URBAN DESIGN REVIEW WATERLOO ESTATE SOUTH

Hassell has been engaged by DPIE to undertake a 'broad and holistic' urban design review of the Waterloo Estate (South) Planning Proposal prepared by the City of Sydney.

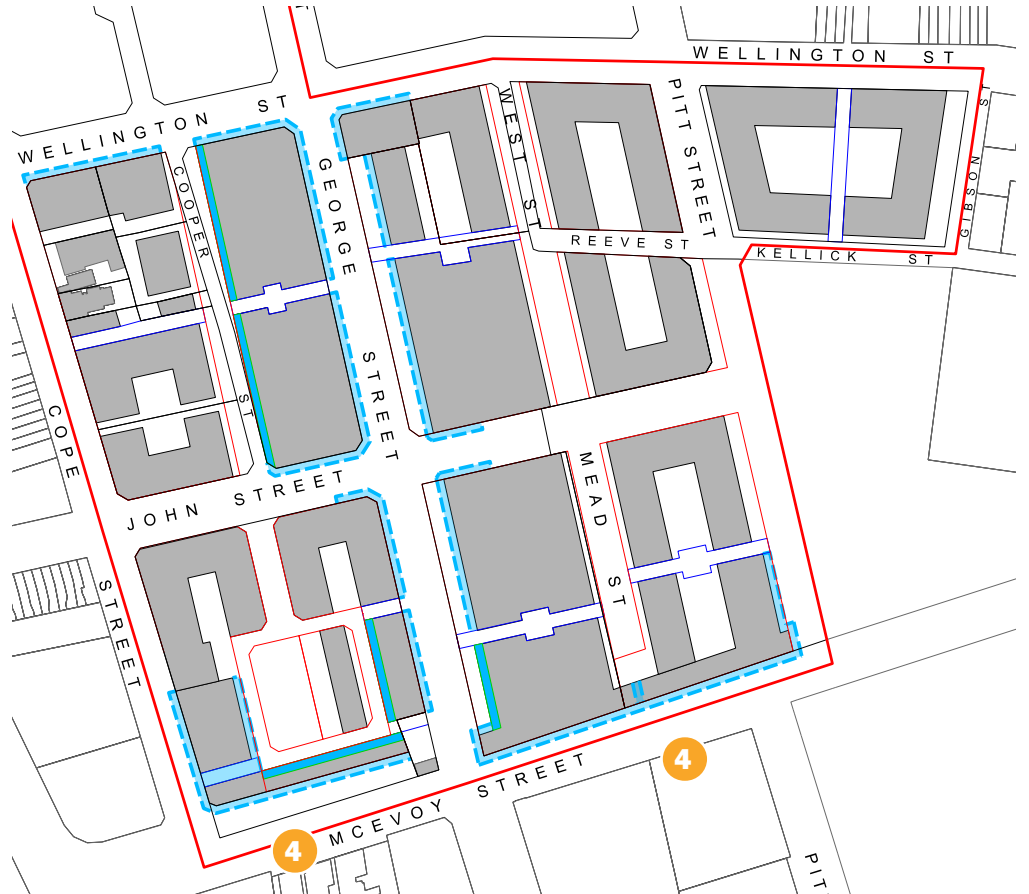
1. Extension of active frontage of the 2 lane ways to the east of George Street does not connect to the street beyond.
2. Active frontage east of McEvoy Street is very close to the busy road.
3. No active frontage to the built form adjacent to the small south east park.
4. Awning are allocated below tower to levitate the effect of down draft wind.
5. Solar access to open spaces (streets, parks, courtyards etc) within in the precinct could be compromised by tall and long buildings, creating cold and dark conditions during winter.

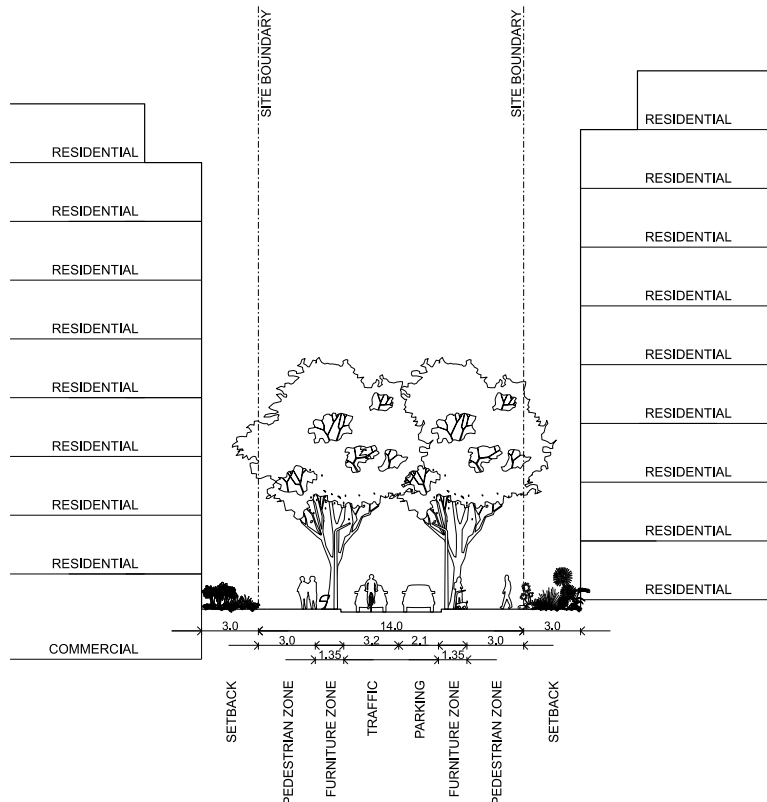
1. Setbacks should relate to use, thermal comfort, opportunities for existing tree retention etc.
2. Inconsistent application along Pitt Street
3. East and west blocks of McEvoy Street have inconsistent setbacks. No setback provision to the eastern block to allow tree retention.

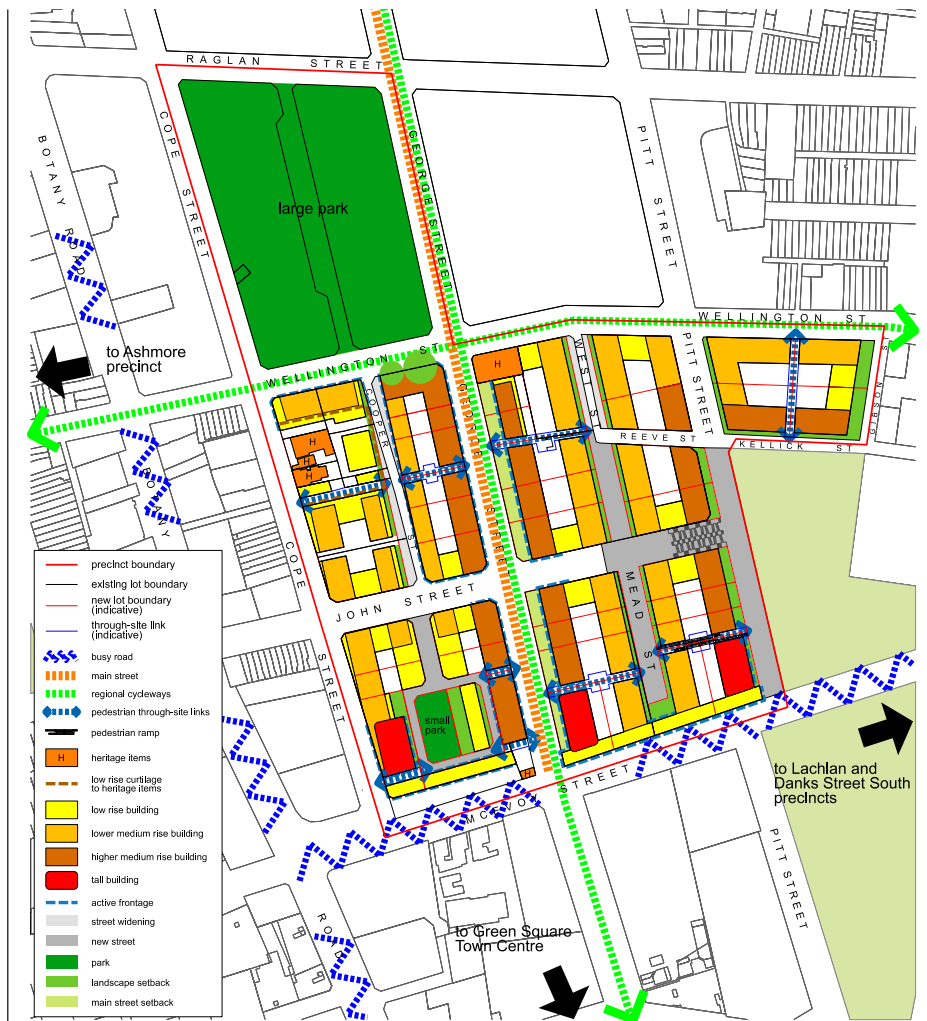
1. The proposed street blocks knit Waterloo South into its urban context and replace former streets that existed prior to its creation as a public housing precinct.
2. No provision for pedestrian connection from Mead Street through to McEvoy Street.
3. No provision for pedestrian connection from small park through to McEvoy Street.
4. Vehicular connection blocked from George Street to McEvoy Street - CoS Planning Proposal notes that the blocked entry from McEvoy Street is to avoid 'rat runs' through precinct. Pedestrian and cycle permeability at this intersection is provided.
5. The location of mid block links provide additional permeability to long street blocks, and are appropriately located.
6. The character of the mid block connections requires careful design attention owing to the scale of adjacent buildings.
7. Mid block links need to be designed to accommodate CPTED principles

Winter Solstice

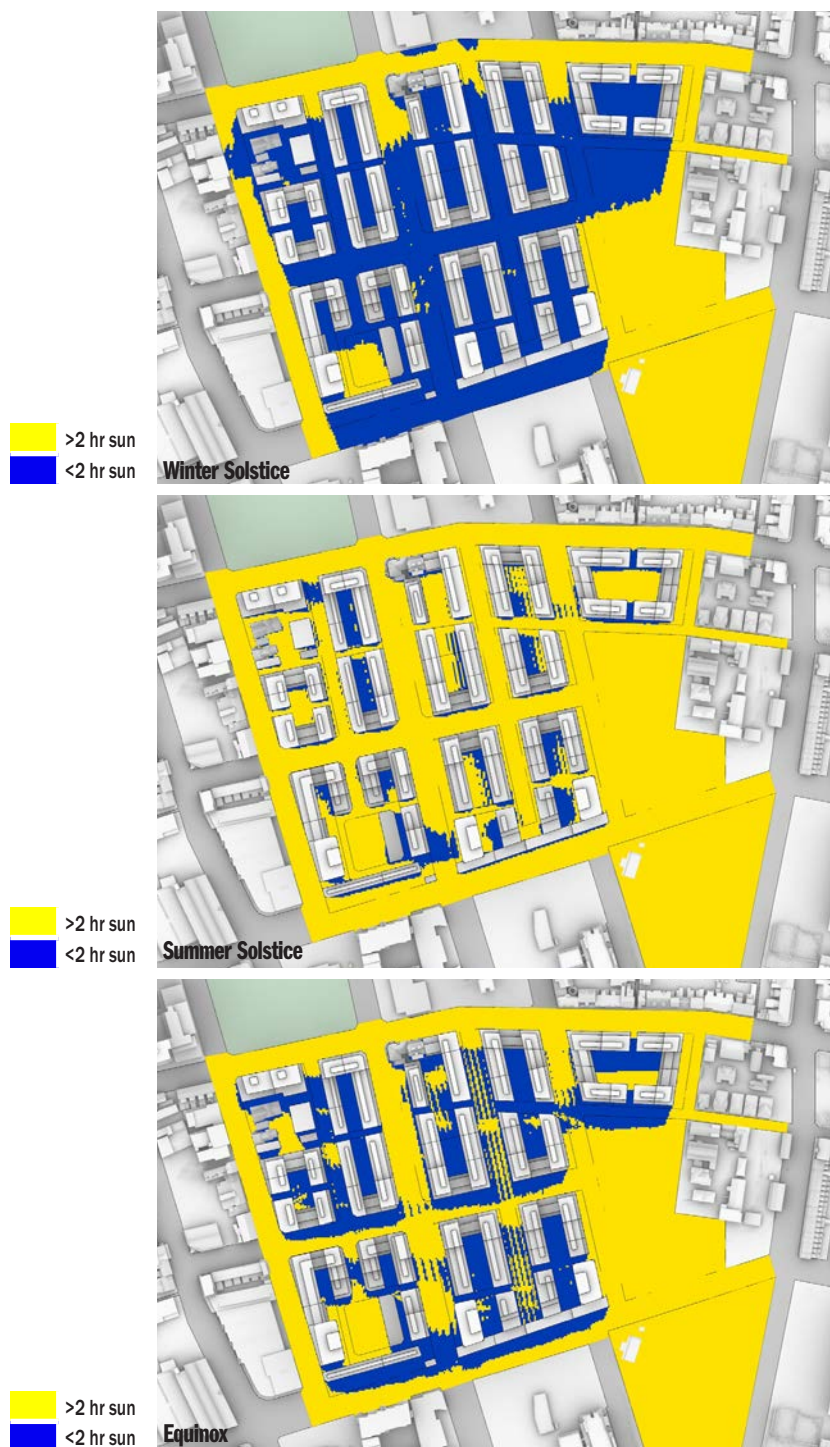
1. All shared courtyard spaces within the perimeter building blocks do not receive a minimum of 2 hour solar access between 9am-3pm mid winter
2. The majority of George Street, Mead Street, West Street, John Street and Cooper Street have minimal access to sunlight between 9am-3pm mid winter.
3. The south west park has good solar access mid winter.

Winter Solstice

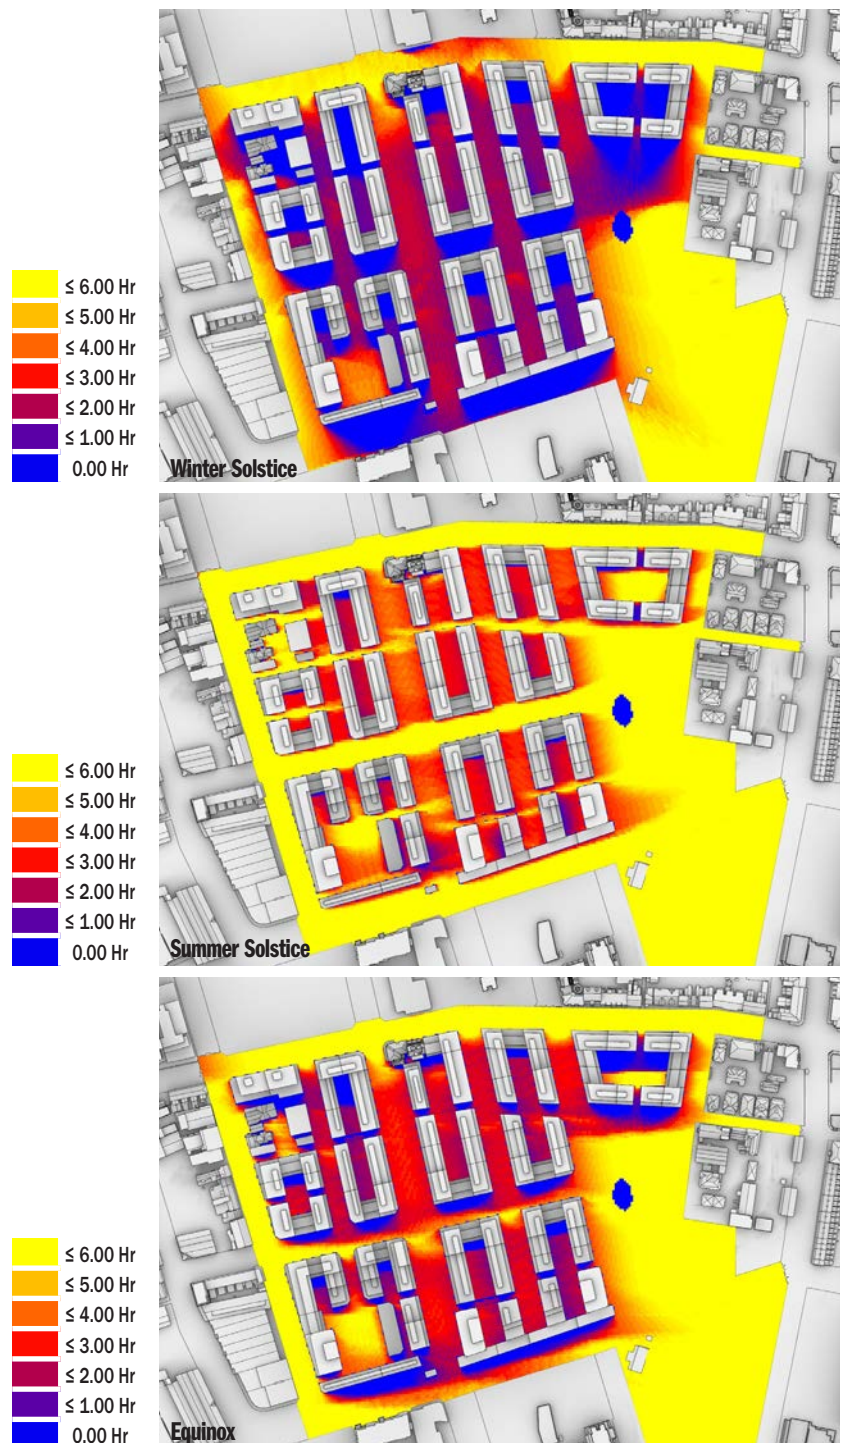
1. Majority of the courtyard spaces within the perimeter building blocks do not receive more than 2 hours of solar access within the extended analysis hours of 9:00am and 5:00pm mid winter
2. There is a high degree of courtyard areas with no access to sunlight.
3. North south streets receives 2-3 hours of solar between 9am and 5pm mid winter.

Equinox

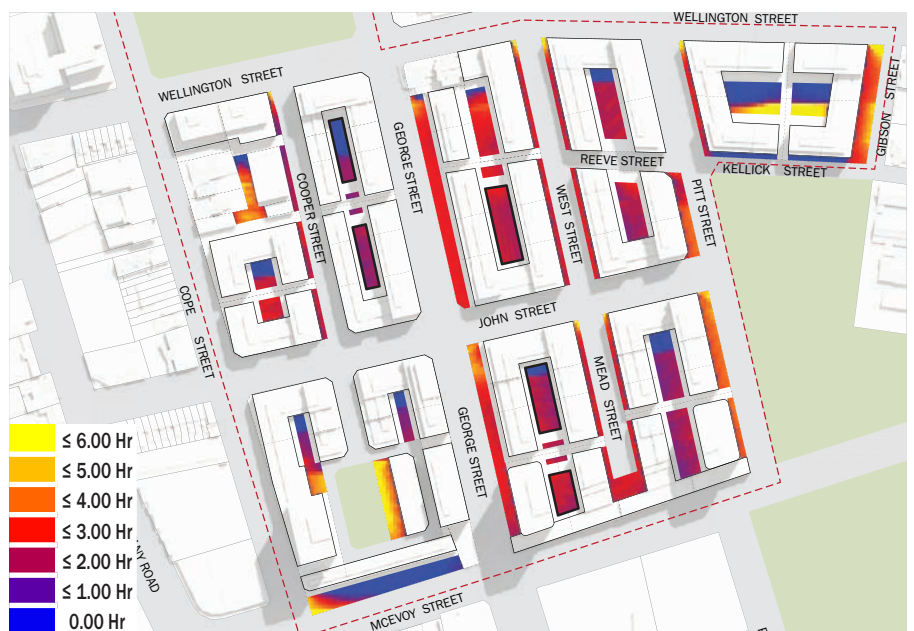
1. Majority of deep soil zone within the courtyards have less than 2 hours of sunlight access.
2. The majority of Cooper Street, Mead and West Street have less than 2 hour access to sunlight.

Planning Proposal

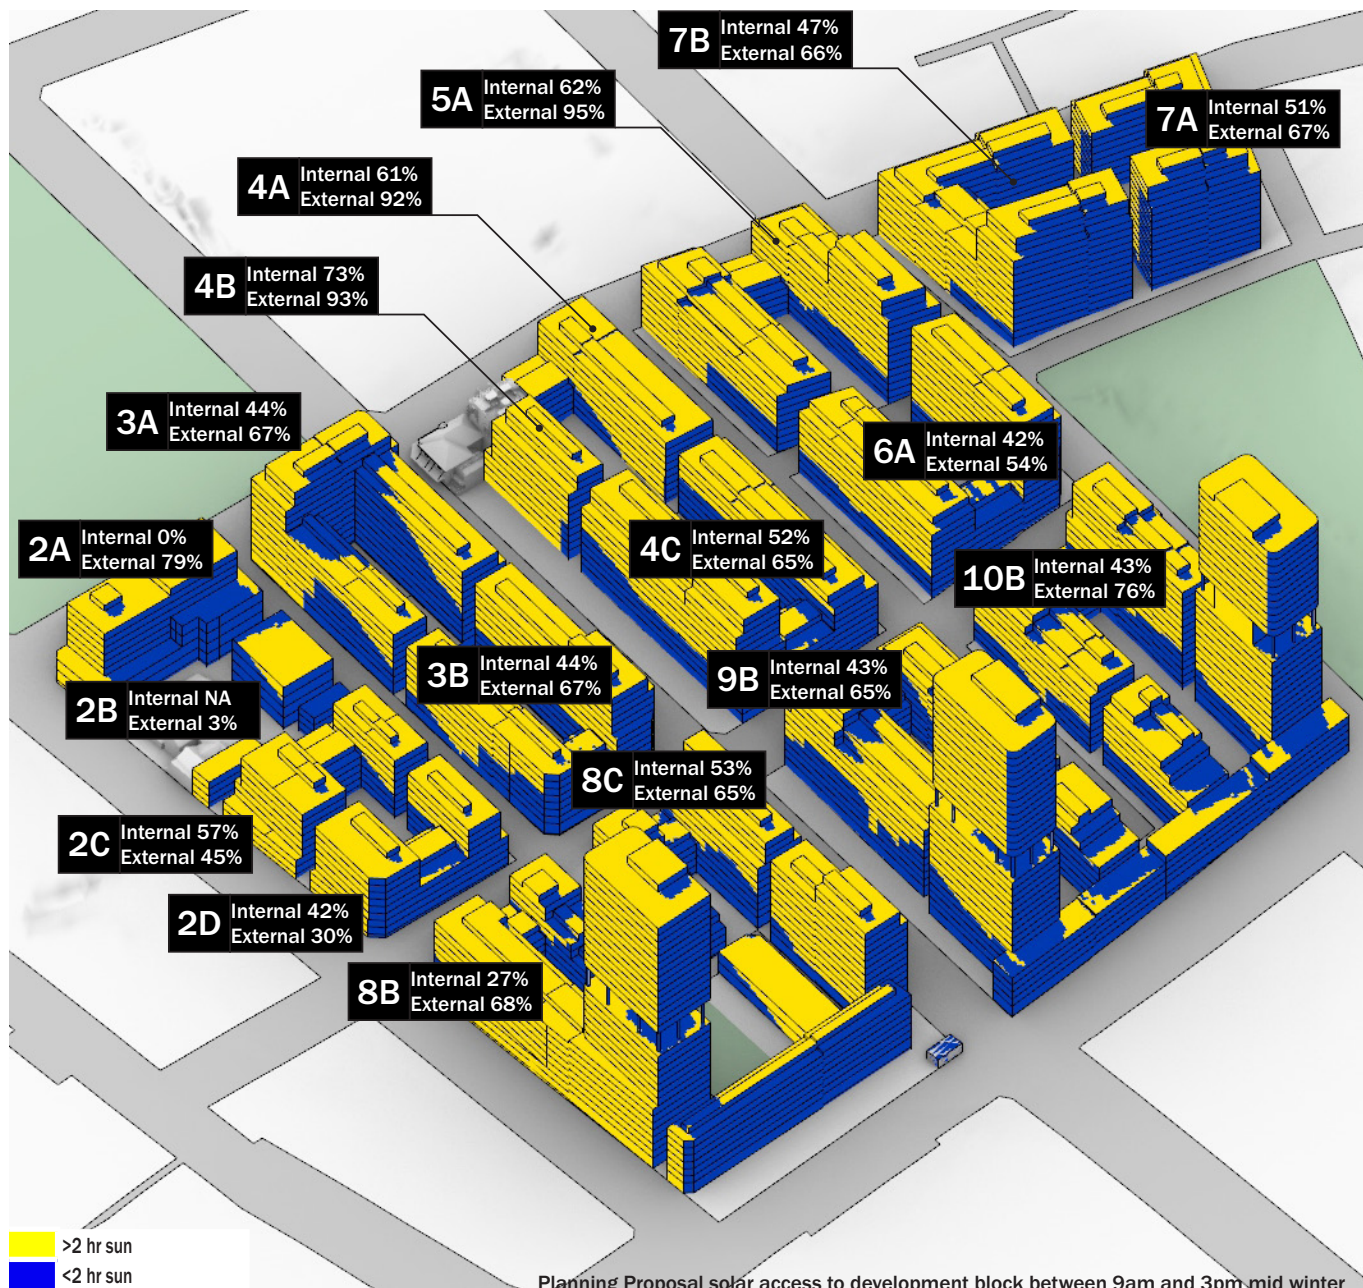
- Due to the height of the buildings proposed, the facade of the buildings are self shaded and overshadowed by adjacent buildings.
- The blocks in the centre of the precinct are the most impacted.
- The external percentage demonstrates in particular the east and west facades where the living rooms and POS will likely be located and the likelihood of compliance.

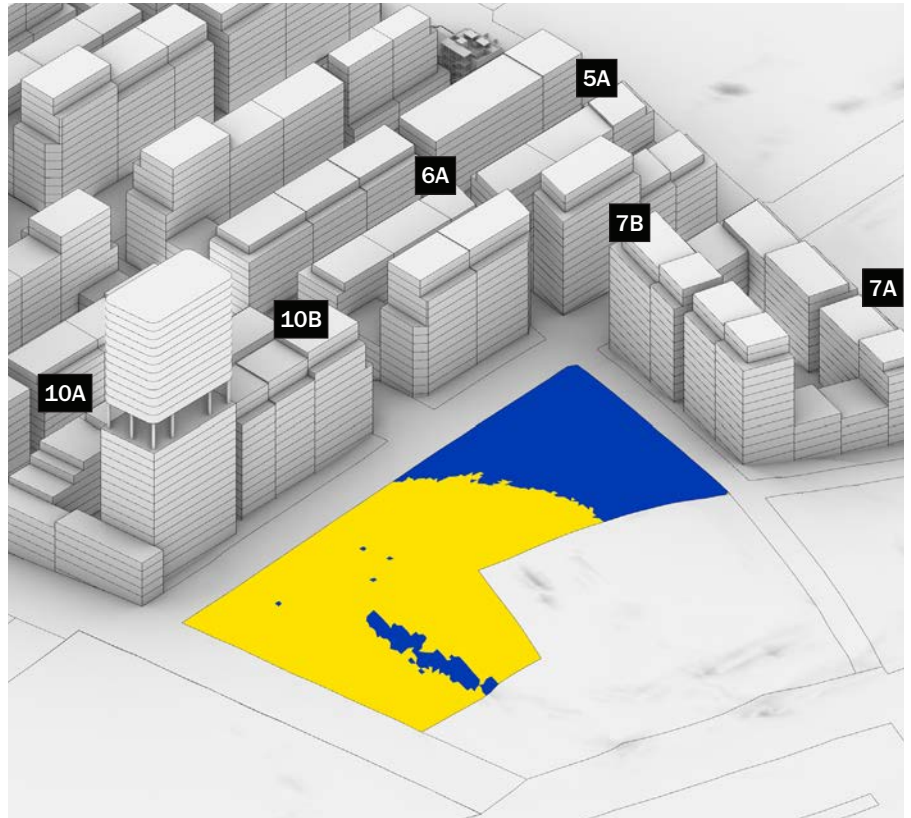
The drawing to the right shows the planning proposal as having:

- In Shadow = 38% / 4836 sqm
- In Sun = 62% / 7812 sqm
- (A minimum of 4 hours+ of 50% of solar access required in winter)

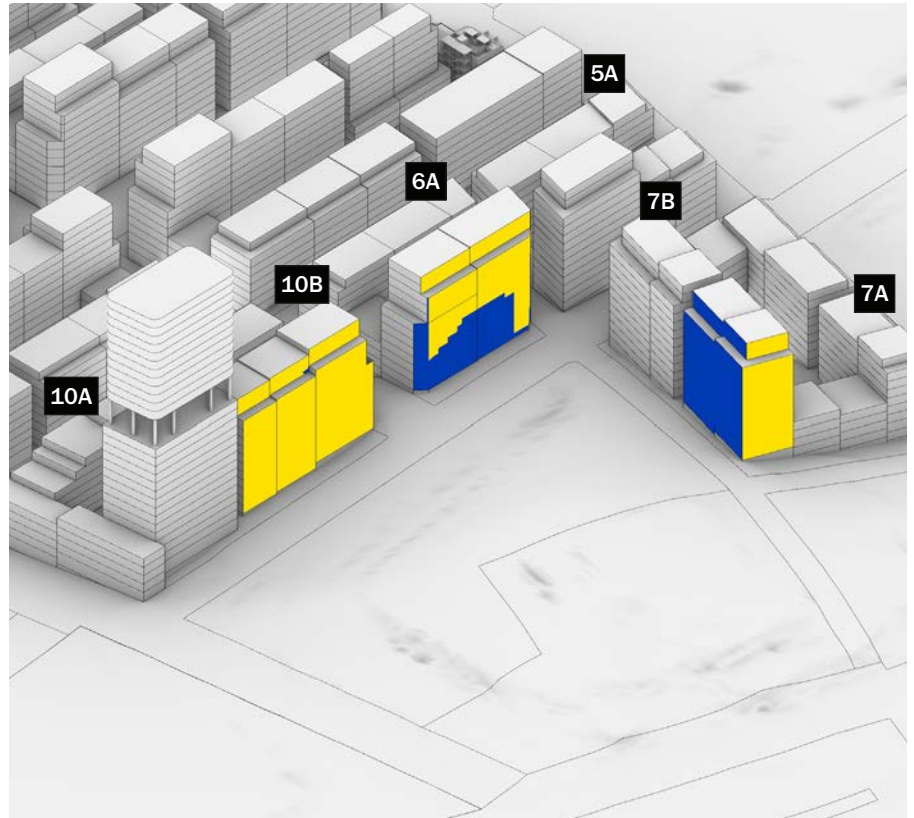
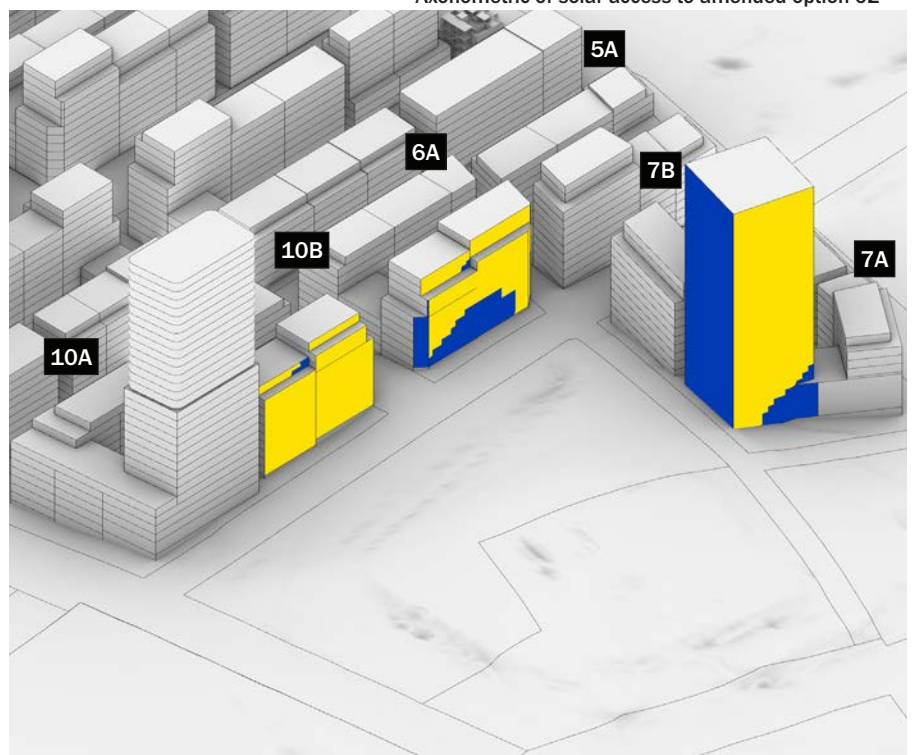
The drawing to the right shows the planning proposal impact to the street facades of future residential development:

- **Block 6A:**
 - In Shadow = 36% / 735 sqm
 - In Sun = 64% / 1290 sqm
 - (A minimum of 2 hours+ of 50% of solar access required in winter)
- **Block 10B:**
 - In Shadow = 0.5% / 10 sqm
 - In Sun = 99.5% / 2158 sqm
 - (A minimum of 2 hours+ of 50% of solar access required in winter)

The amended building envelope has an improved outcome:

- **Block 6A:**
 - In Shadow = 31% / 508 sqm
 - In Sun = 69% / 1130 sqm
 - (A minimum of 2 hours+ of 50% of solar access required in winter)
- **Block 10B:**
 - In Shadow = 2% / 26 sqm
 - In Sun = 98% / 1444 sqm
 - (A minimum of 2 hours+ of 50% of solar access required in winter)
